Service Note

08-004A February 27, 2008

M703E IMPROVED RESPONSE REWORK INSTRUCTIONS

Figure 1

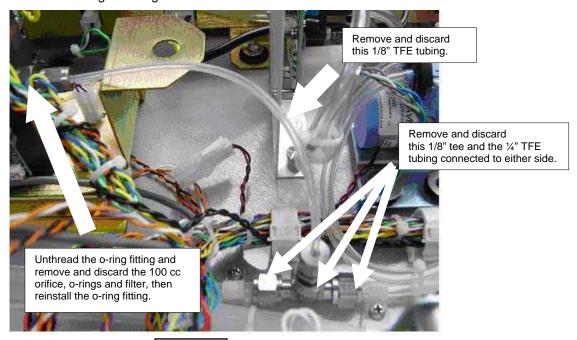
- 1. Disconnect and discard the 1/8" Teflon tubing that leads between the output of the O₃ generator and the top of the stainless steel tee. See Figure 1.
- 2. Remove the stainless steel tee and the ¼" Teflon tubing that runs to the output manifold and to the 5 LPM orifice holder on the regulator assembly. See Figure 1.
- 3. Unthread the stainless steel o-ring fitting from the output of the O3 generator and remove the 100CC flow orifice, o-rings and filter. Reinstall the stainless steel o-ring fitting being careful not to over tighten. It should be snug. See Figure 1.

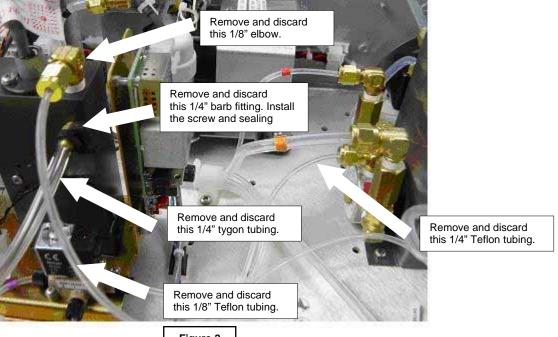
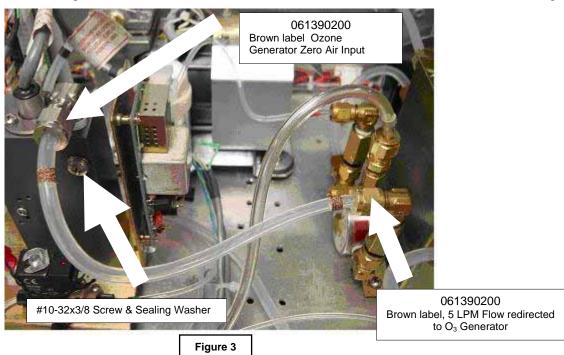
- 4. Disconnect and discard the $\frac{1}{4}$ " tygon tubing that lead fitting on the O₃ generator. Replace the brass bar fitting with the #10-32x3/8 screw (SN 18) and sealing washer (HW 149) from the kit. See Figures 2 and 3.
- 5. Disconnect the O_3 generator lamp from ".e power supply. Carefully remove the lamp from $\cap e O_3$ generator.
- 6. Remove and discard the 1/8" brass elbow from the top of the ozone generator together with the 1/8" Teflon tubing that leads to the brass tee on the regulator assembly. See Figure 2.

- 7. Install the new ¼" brass elbow to the top of the ozone generator.
- 8. Connect one end of the brown labeled $\frac{1}{4}$ " Teflon tubing included in the kit to the brass elbow on top of the O₃ generator and the other end to the brass elbow on the 5 LPM flow control. See Figure 3.

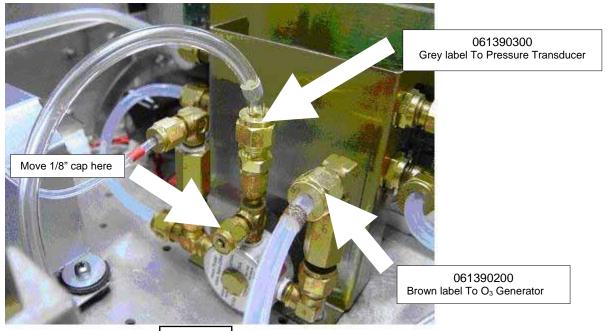
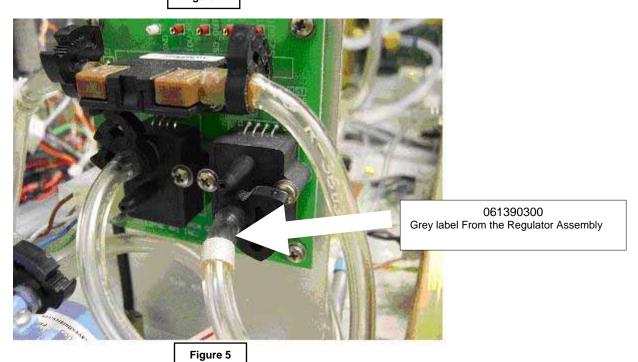
- 9. Move the 1/8" brass cap from the top of the tee on the regulator assembly to the lower port on the same tee. See Figure 4.
- 10. Connect the open end of the grey labeled $\frac{1}{4}$ " tygon tubing included in the kit to the bottom port on the pressure transducer. Connect the other end of the grey tubing with the stainless steel $\frac{1}{4}$ " to $\frac{1}{8}$ " reducer to the $\frac{1}{8}$ " tee on the regulator assembly. See Figures 4 and 5.

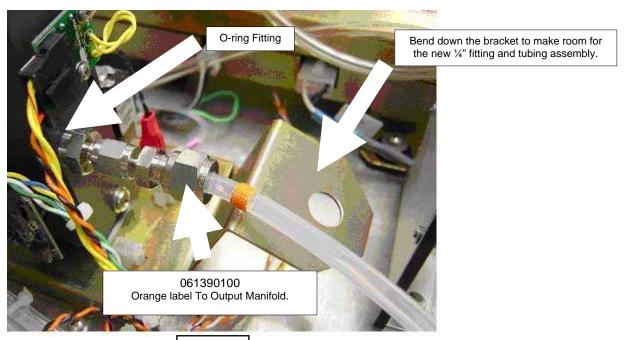
11. Bend down the bracket to make room for the new ¼" reducer fitting and tubing assembly. See Figure 6.

Figure 7

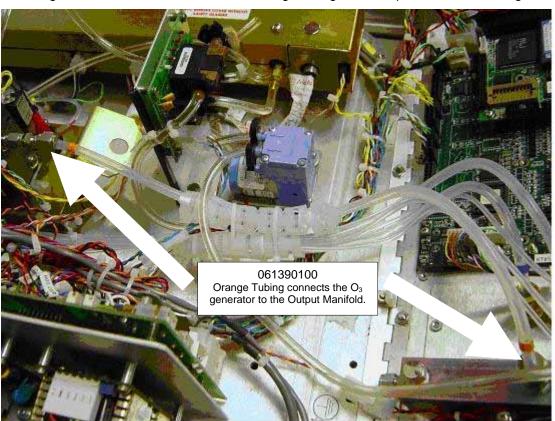
12. Connect the end of the orange labeled tubing with the stainless steel reducer to the output of the ozone generator and the other end of the orange tubing to the output manifold. See Figure 7.

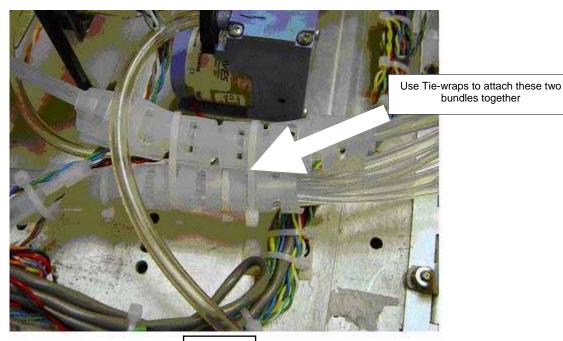
13. Use tie-wraps to attach the two tubing bundles together. See Figure 8.
